Staff Technical Position on Investigations to Identify Fault Displacement Hazards and Seismic Hazards at a Geologic Repository

U.S. Nuclear Regulatory Commission

Manuscript Completed: April 1992
Date Published: July 1992

FIGURE 1 — Example of an Acceptable Approach to the Identification of Fault Displacement Hazards and Seismic Hazards. Numbers next to the process blocks correspond to the technical position statements described in the text. See Figure 3 for an expansion of process block 3.1.3.

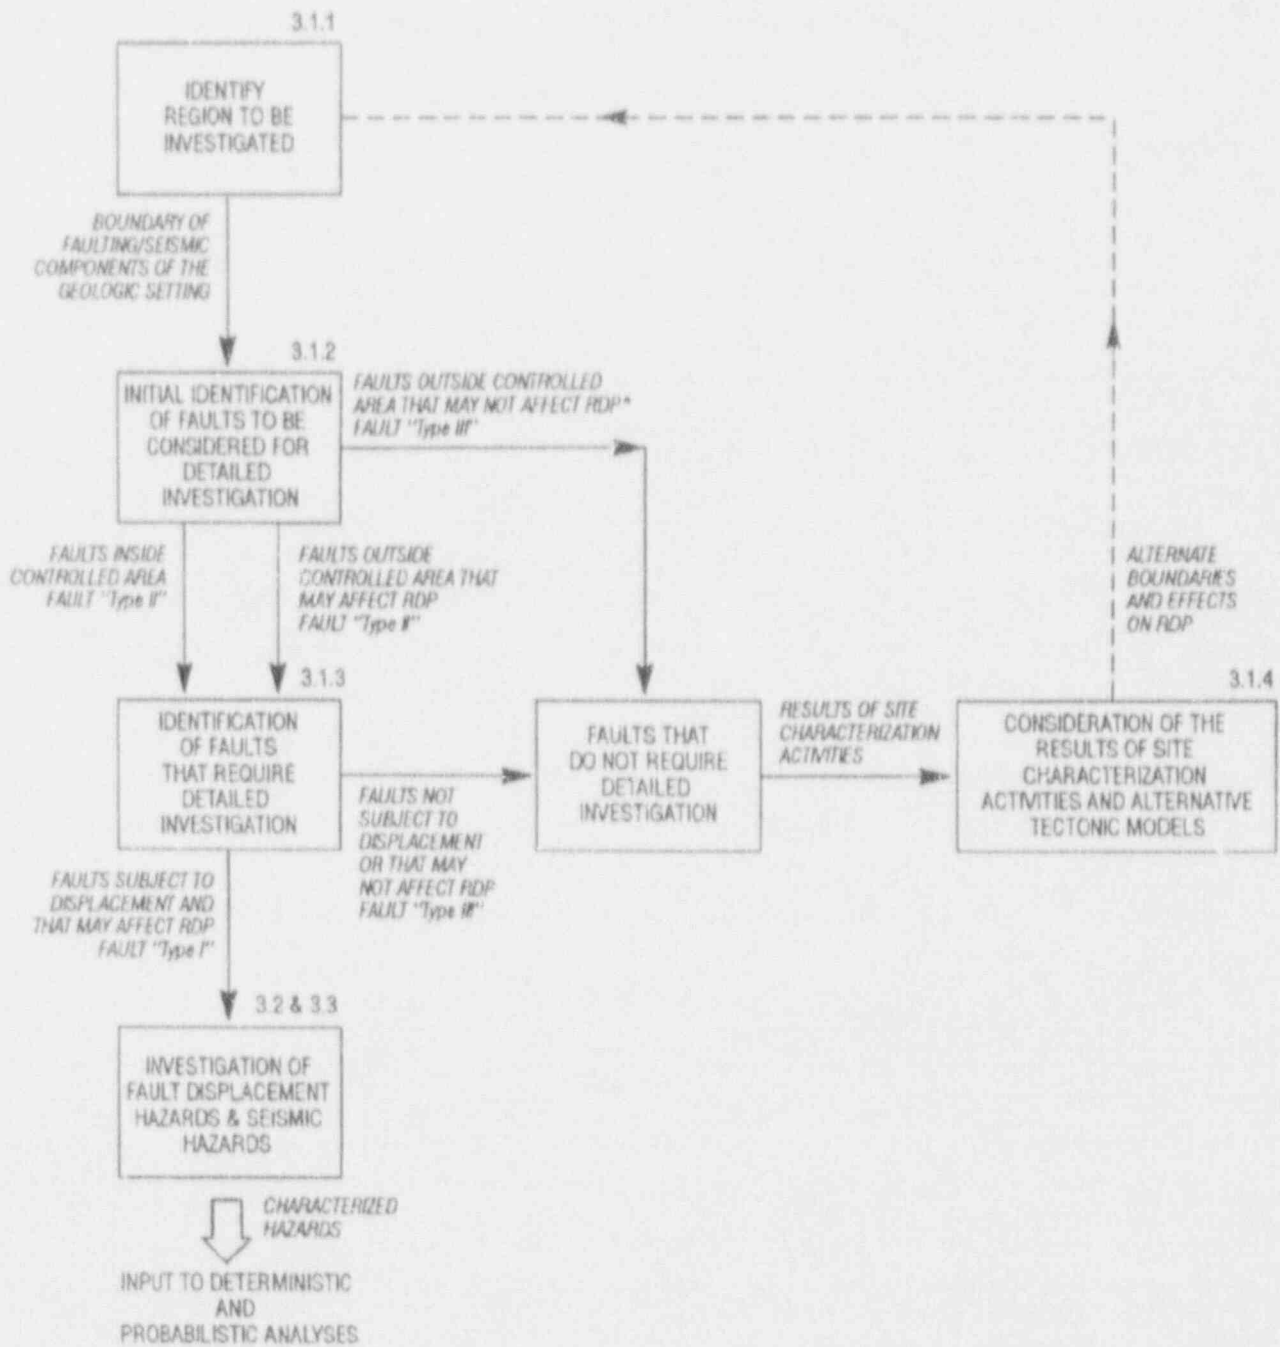
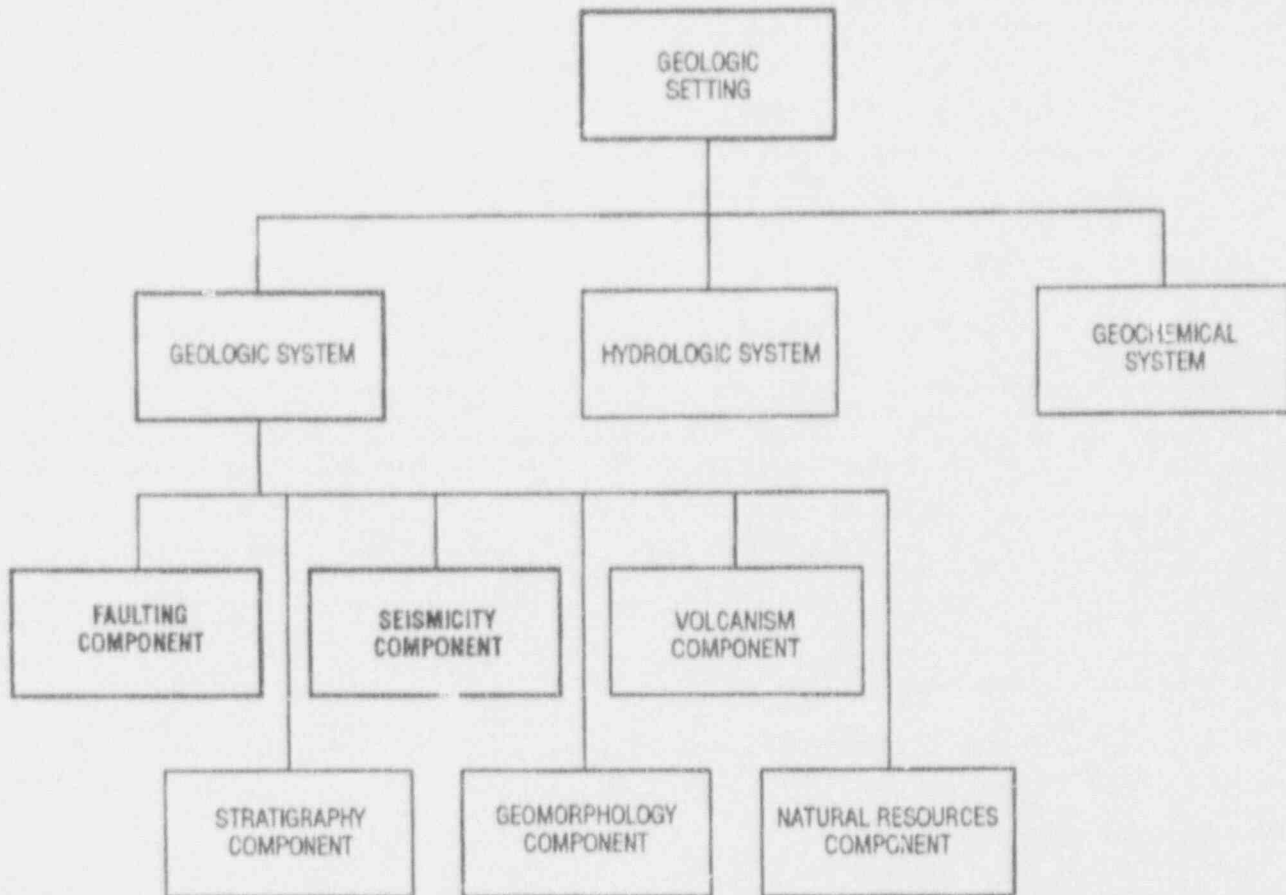
The STP should not preclude the use of probabilistic assessments of candidate faults lying outside the controlled area. A clarifying statement that a qualitative probabilistic performance assessment is acceptable should be added to the text accompanying Figure 1.

The definitions given on Figure 2, page 26 that the "region is within the geologic setting [sic] and on page 6, item (2) where "components of the geologic system (are) acting within the geologic setting" appear to be in conflict with each other and the definition for geologic setting given here. The conflict might be resolved if the glossary was expanded to include the definition(s) for the various "systems," "settings," and "components." In addition, although the "geologic setting" definition is cast in the concrete language of 10 CFR Part 60, this glossary offers an ideal opportunity to remedy shortcomings of the 10 CFR Part 60 language by expanding on that definition, particularly as it relates to the southern Basin and Range region that includes Yucca Mountain.

The staff considers that the term "region" can have varying definitions, depending on the application. With respect to Figure 2, the term refers to the area which encompasses the boundaries of the "geologic," "hydrologic," and "geochemical" system settings; with respect to the definition of "geologic system setting," the

how the constituent parts, themselves, may be viewed. However, in response to this comment, the staff has revised the text in Subsection 3.1.1 and Figure 2 to further clarify the staff's intent in this area.

Figure 3 — Staff Technical Position 3.1.3: Detail to the "Approach to the Identification of Faults that Require Detailed Investigation (i.e., "Type I" Faults)". Refer to the text for the discussion of this two-step process. Also see Figure 1.

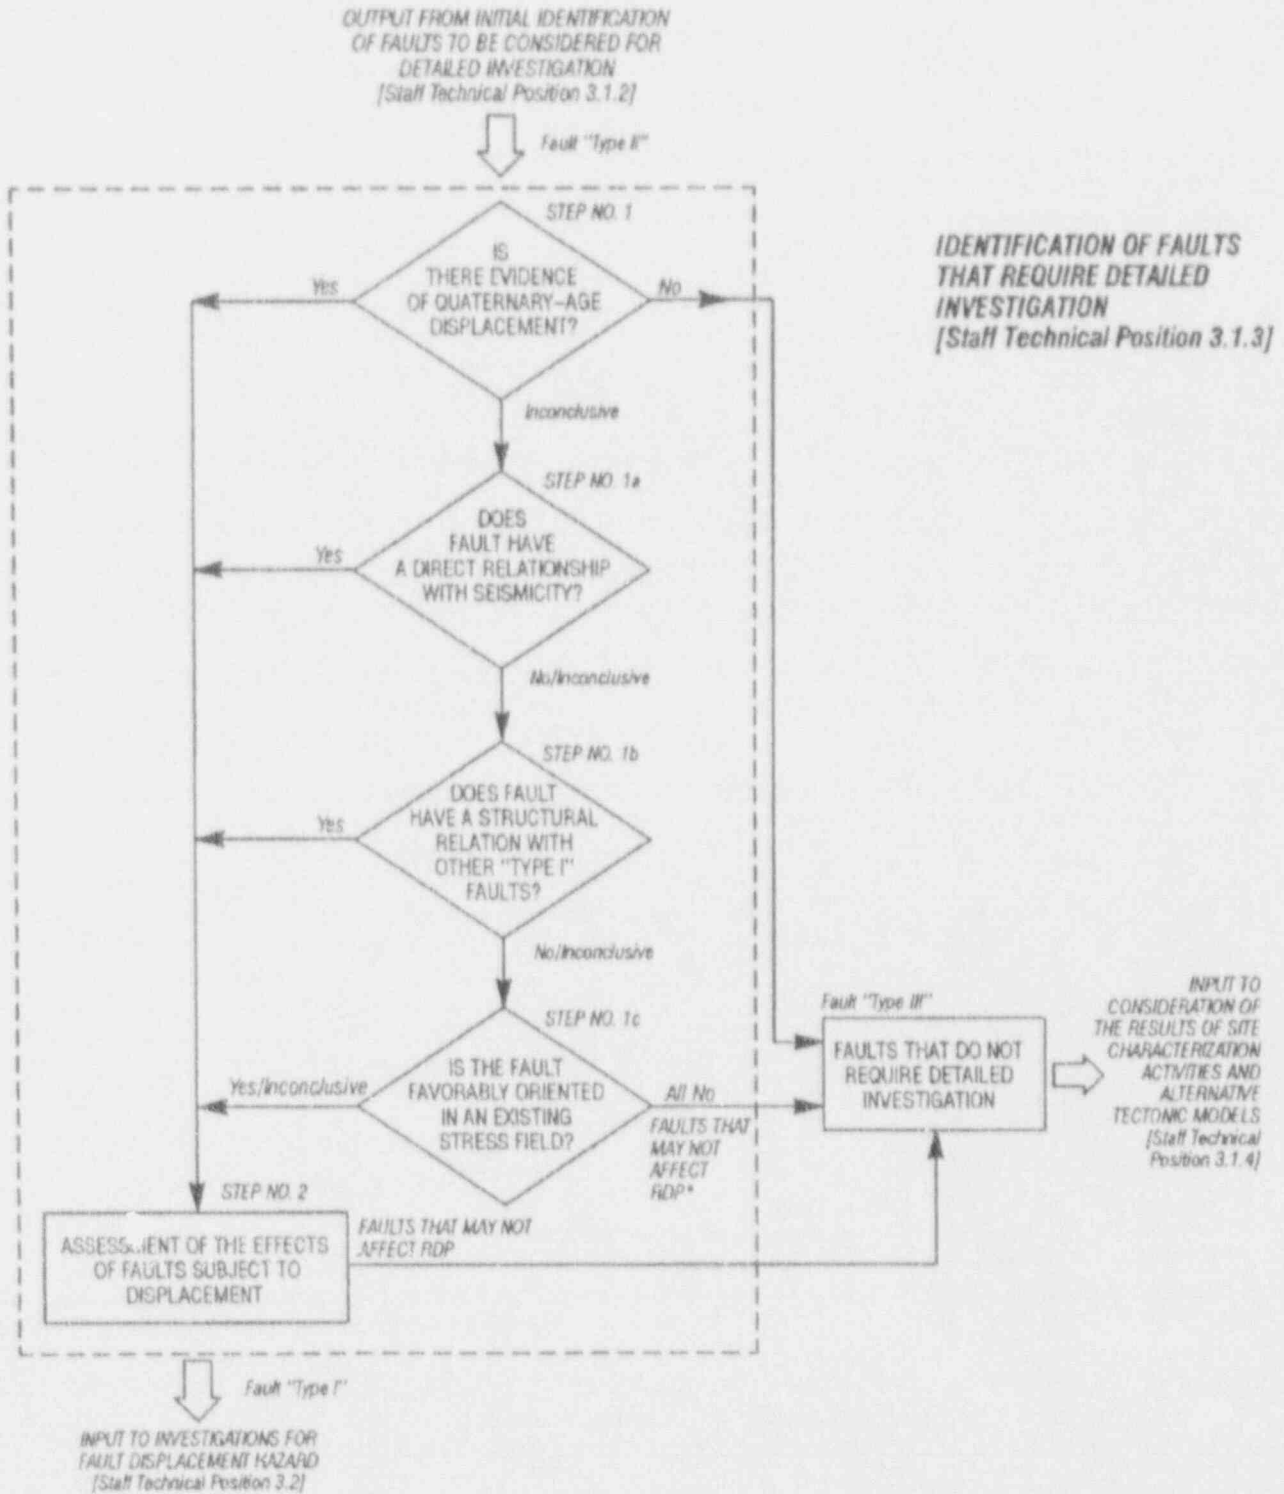
The staff should revise Figure 3 of the STP to indicate that only if Quaternary-age evidence is incomplete or unclear, should secondary criteria be evoked.

The staff agrees with this comment and has revised both the text and Figure 3, as suggested.
